## ADDENDUM NO. 1

**PROJECT NAME:** Henzlik Hall Redecoration- Phase 2  
**UNL PROJECT NUMBER:** C055P113  
**BID INVITATION NUMBER:** 2263-13-7200

**DATE OF ISSUANCE:** November 8, 2013  
**DATE OF BID OPENING:** November 12, 2013

PROJECT UNL Henzlik Hall Redecoration – Phase 2

HENZLIK HALL PHASE 2  
MAIN LEVEL - ELECTRICAL

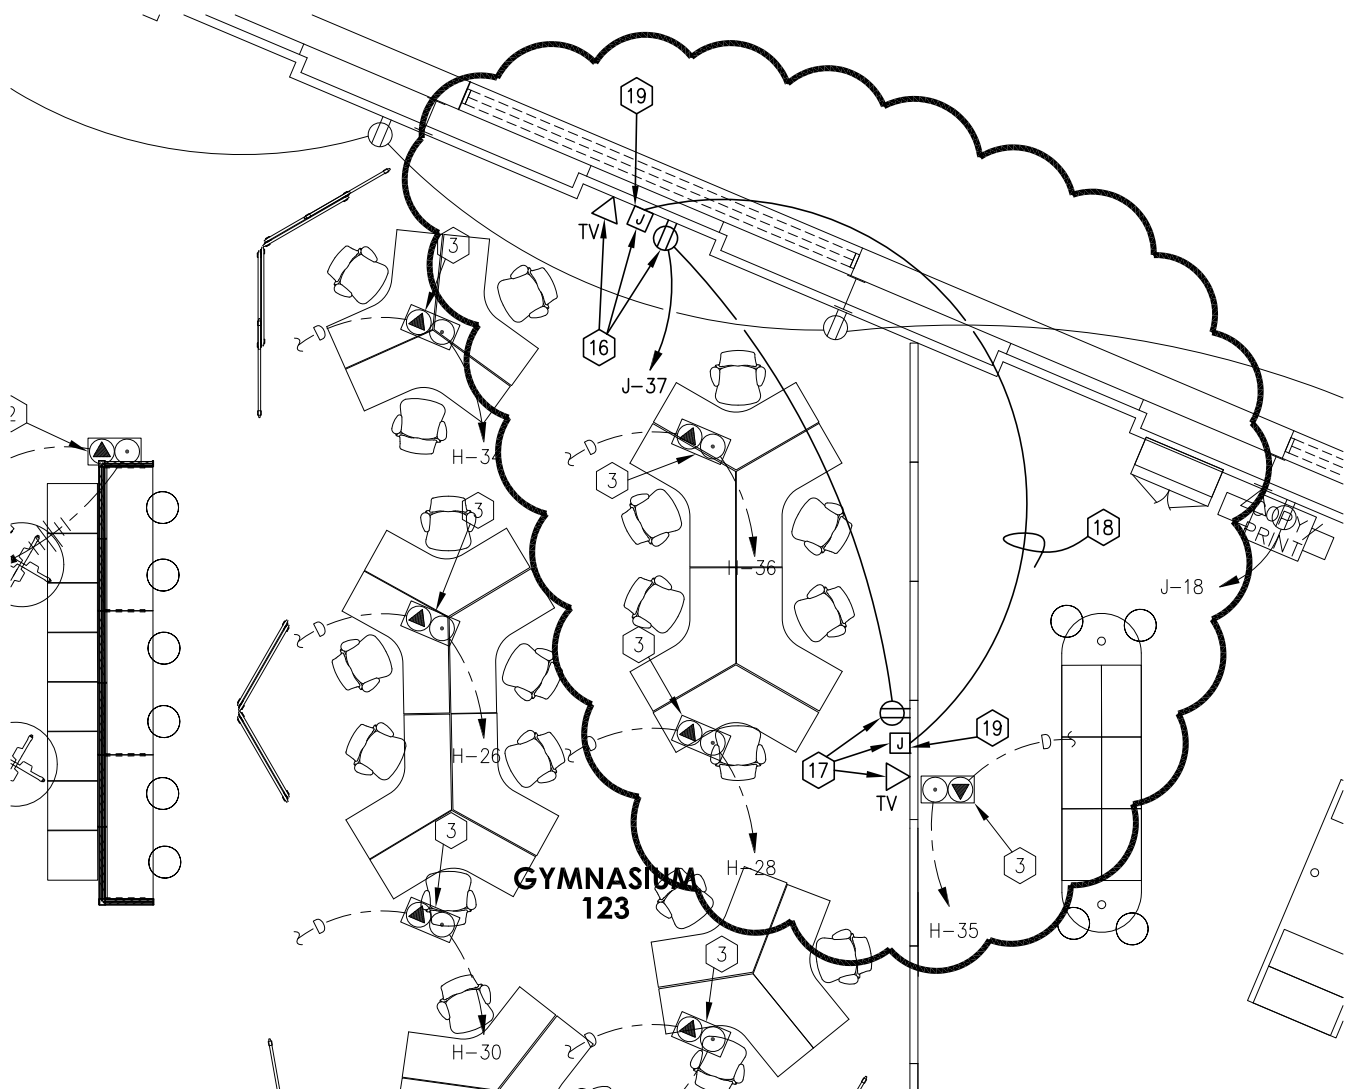
- Refer to sheet E3 – Main Level Floor Plan Electrical. See attached drawing E3 Attachment 1, Dated 11.06.2013 for additional data, t.v. and receptacles in Gymnasium 123.

- 1. Sheet E3 Main Level Floor Plan - Electrical
  - A. Data, TV and Receptacles added in Gymnasium 123. See Sheet E3 attachment 1.

16. COORDINATE EXACT MOUNTING HEIGHT AND LOCATION OF RECEPTACLE, DATA/AV AND TV WITH ARCHITECT PRIOR TO ROUGH-IN.
17. COORDINATE EXACT MOUNTING HEIGHT AND LOCATION OF RECEPTACLE, DATA/AV AND TV WITH ARCHITECT AND FURNITURE SUPPLIER PRIOR TO ROUGH-IN. POWER AND DATA SHALL BE FED FROM THE NORTH WALL INTO THE WALL SYSTEM.
18. PROVIDE 1 1/4" CONDUIT FROM DATA LOCATION ON NORTH WALL TO DATA LOCATION IN WALL SYSTEM. CONDUIT SHALL BE ROUTED FROM NORTH WALL INTO WALL SYSTEM. COORDINATE EXACT LOCATIONS OF DEVICES WITH ARCHITECT AND FURNITURE SYSTEMS SUPPLIER PRIOR TO ROUGH-IN.
19. PROVIDE 4" X 4" JUNCTION BOX THAT IS DEEP ENOUGH TO ALLOW FOR A 1 1/4" CONDUIT.
